**SUBJECT:** CITY COUNCIL 'BUMP-UP' REQUEST FOR SITE PLAN APPROVAL FOR THE SOUTH BARRIE SECONDARY SCHOOL (225 PRINCE WILLIAM WAY)

5. The purpose of this report is to recommend denial of the Site Plan Application submitted by the Simcoe County District School Board for the proposed 3-storey South Barrie Secondary School within the Hewitt's Secondary Plan Area. Staff are only recommending approval subject to the proposed school being relocated toward the northern limits of the subject lands.
6. The Site Plan Approval would normally be processed by way of delegated approval granted by Council to Staff. However in this case, the applicant has advised staff that they are not in agreement with certain conditions of the site plan approval. The Director of Planning Services and other City staff have met with the applicant and their consultants on several occasions and

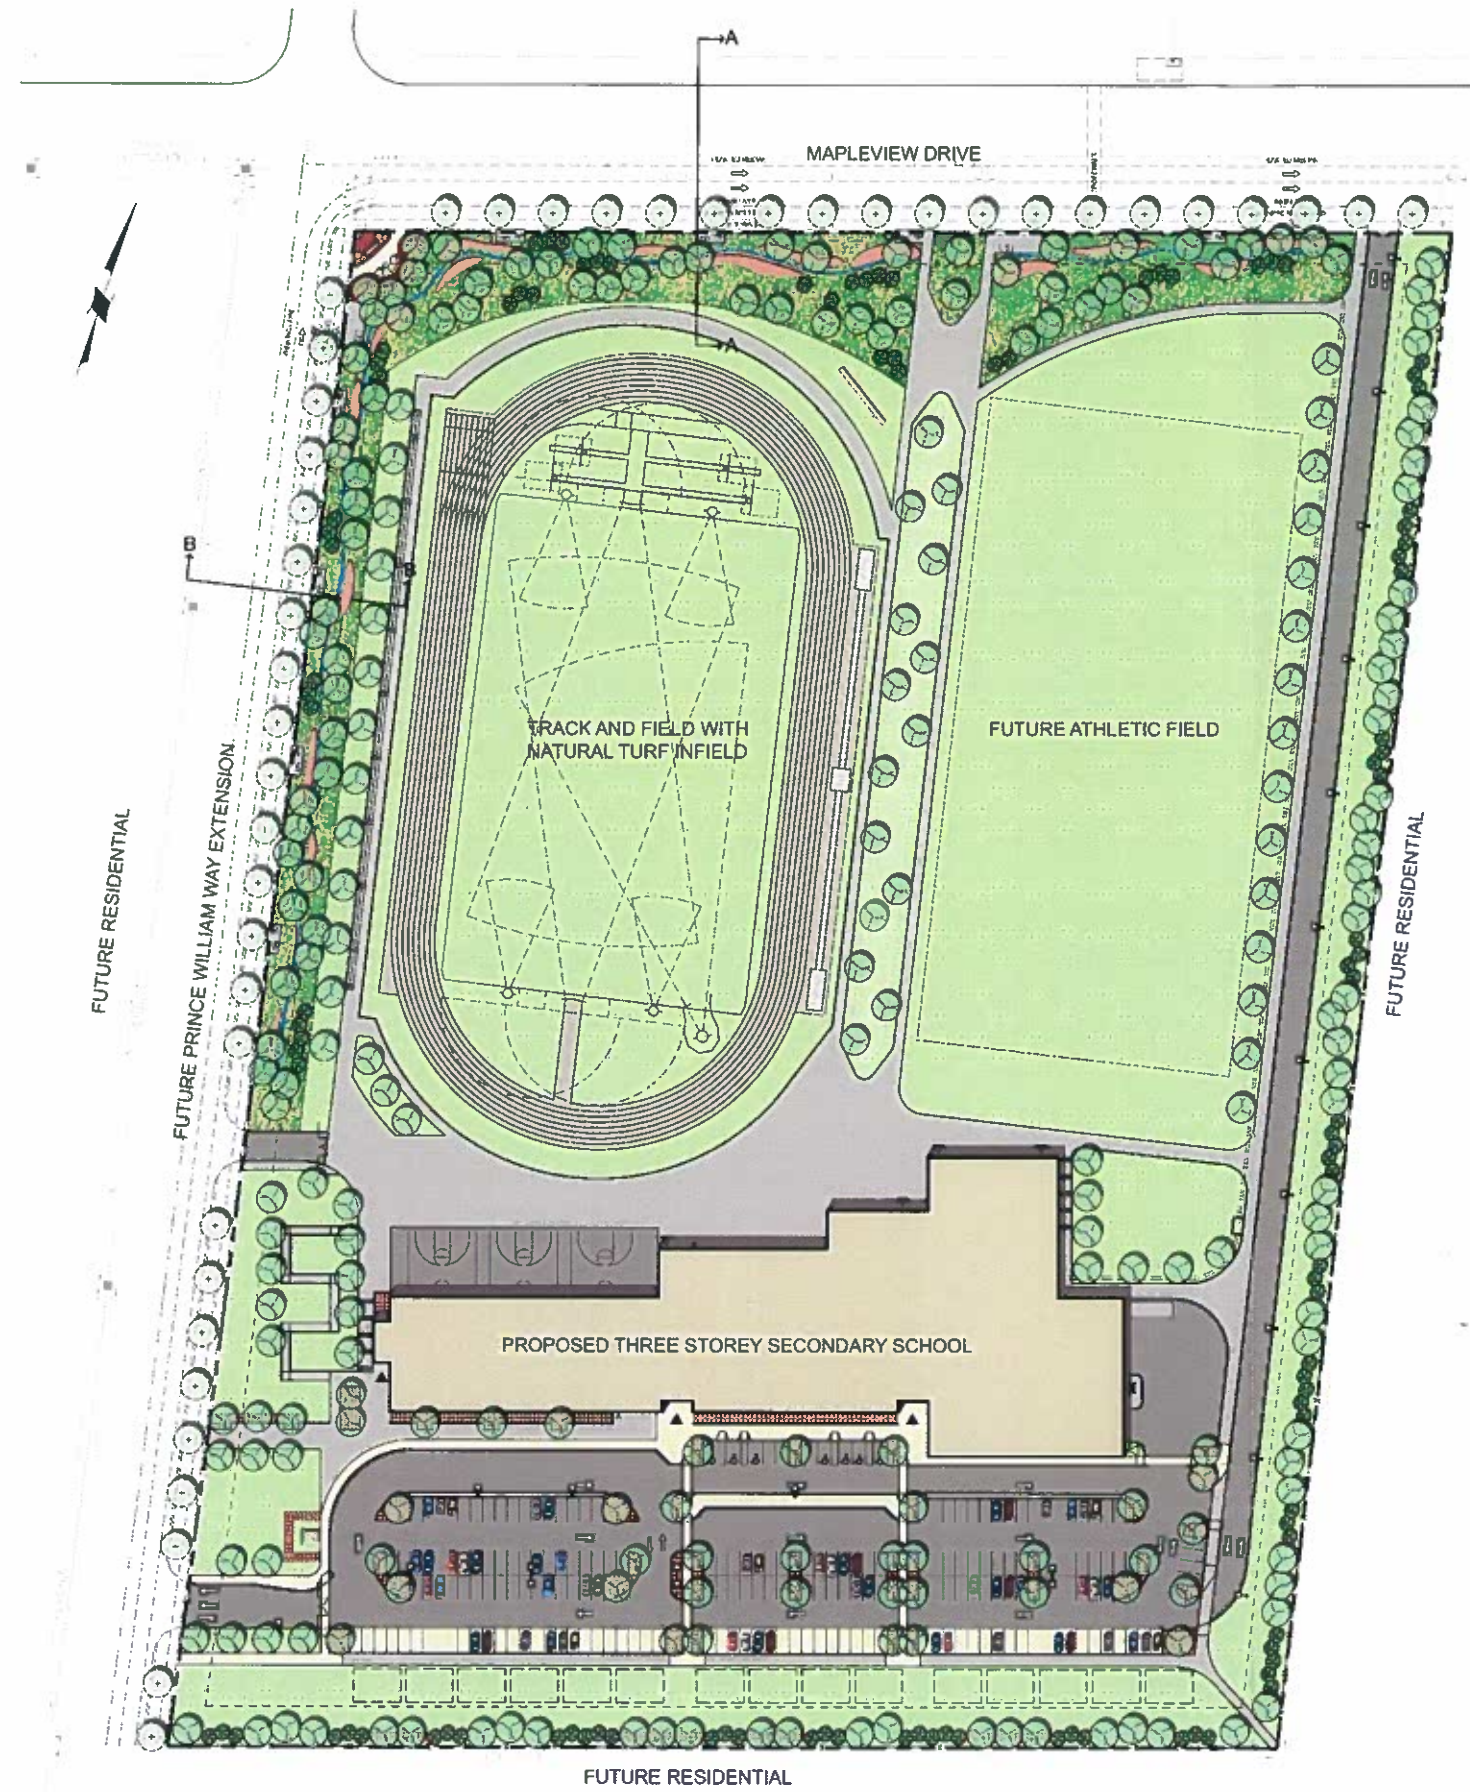
On June 10, 2015, Planning Staff met with the applicant to further discuss the concerns with the location of the proposed school on site but were again unable to reach a satisfactory resolution.

A follow up meeting was held on June 30, 2015 with all interested parties, however, the parties were unable to reach a satisfactory resolution with respect to the location of the building. It was however confirmed at this meeting by the Engineering consultants for both the School Board and the Hewitt's Landowners Group, that the existing topography of the subject lands did not preclude the development of the school toward the northern limits of the site as recommended by Planning Staff.

The technical site plan meeting was held on July 30, 2015 to address the formal Site Plan Application submission. While the placement of the building was still the primary issue of concern for Planning staff, a number of other technical site plan matters from various departments were discussed with the applicant at this meeting. The applicant and their consultants are continuing to work out the balance the technical site plan related matters and staff are confident that these issues will be adequately addressed and resolved through the typical site plan process.

SHEET NUMBER  
**A401**

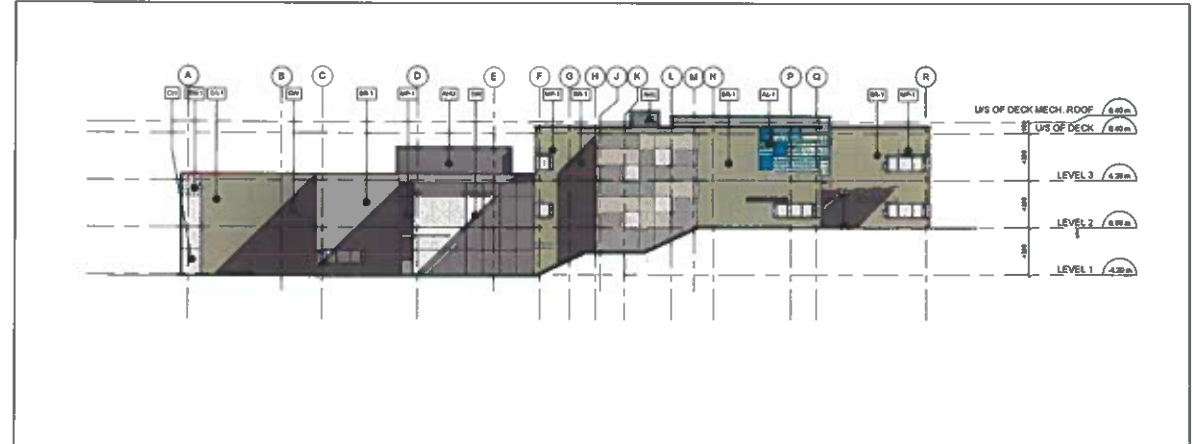
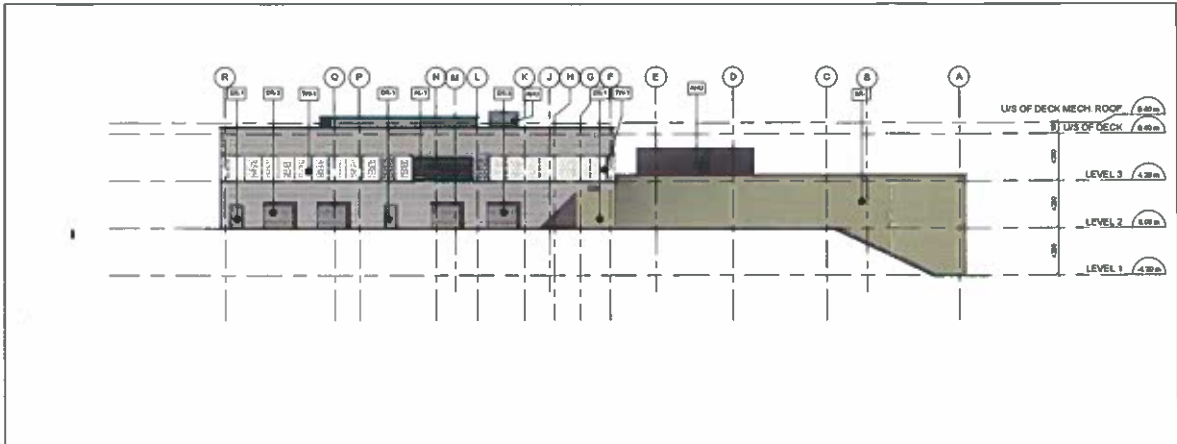
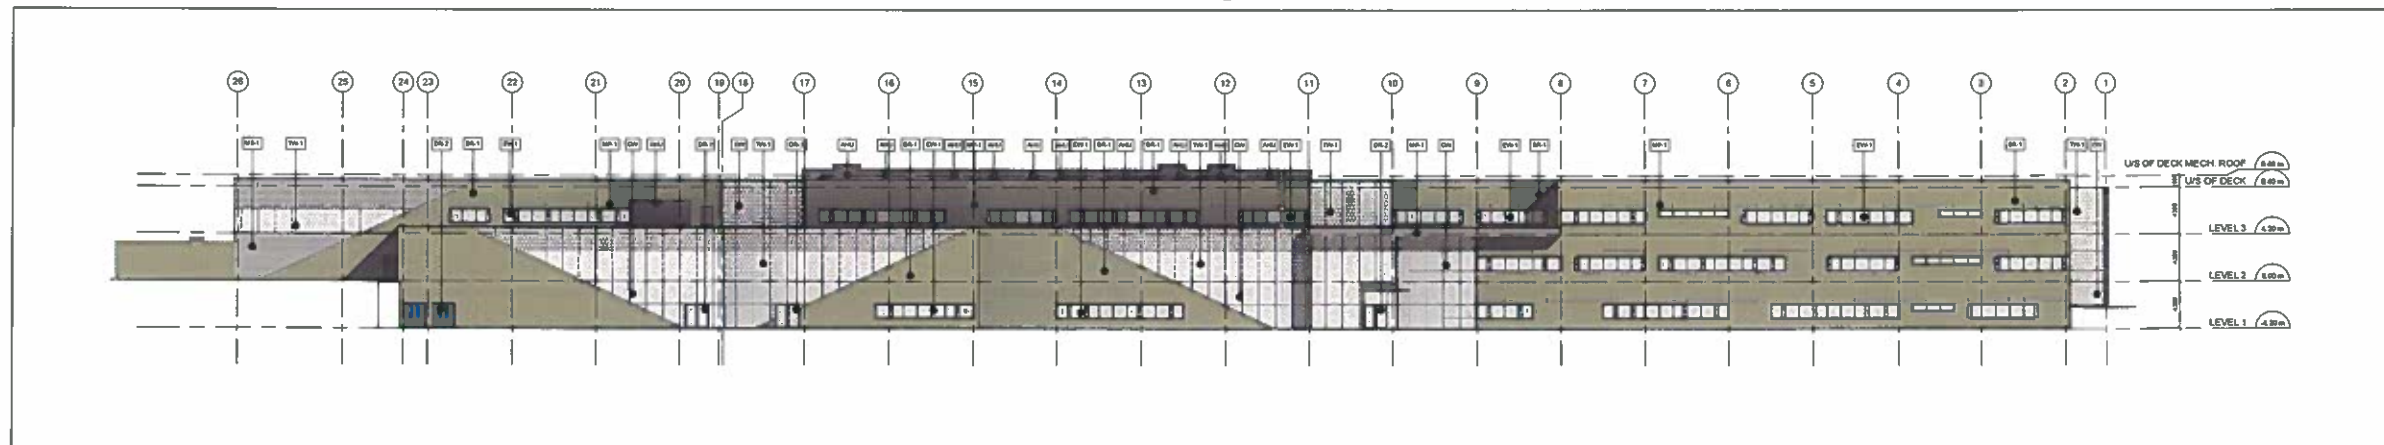
The Secondary Plan policies and Urban Design Guidelines recommend a high level of design for arterial streets, particularly in the mixed use corridor and nodes. It directs that buildings, structures and landscaping be designed to provide visual interest to pedestrians, as well as a sense of enclosure to the street. The school site is not located in a mixed use corridor or node, but in a residential area with existing reverse lot frontage on the north side of Mapleview Drive. Placing the school building at the street line of Mapleview Drive cannot create the same interactive urban environment that is desired in the mixed use corridors and nodes. Schools by their nature have increased security standards, not required of most other land uses, which are intended to control access during school hours in order to preserve student and staff safety. Locating the facility at the intersection, while perhaps aesthetically pleasing, would not enhance pedestrian and community interaction since the main pedestrian entrance would need to be associated with the parking, bussing, and supervised entrance. Any points of building access along Mapleview Drive and Prince William Way would need to be controlled and limited thereby effectively resulting in "dead walls" along these streets; this result would not align itself with the general intent of the Urban Design Guidelines and secondary plan policies. Locating the playing fields at the Mapleview Drive frontage can provide considerable visual interest, a view of the secondary school, and a pedestrian friendly active use interface as opposed to a 3-storey and approximately 550-foot wide secured structure.
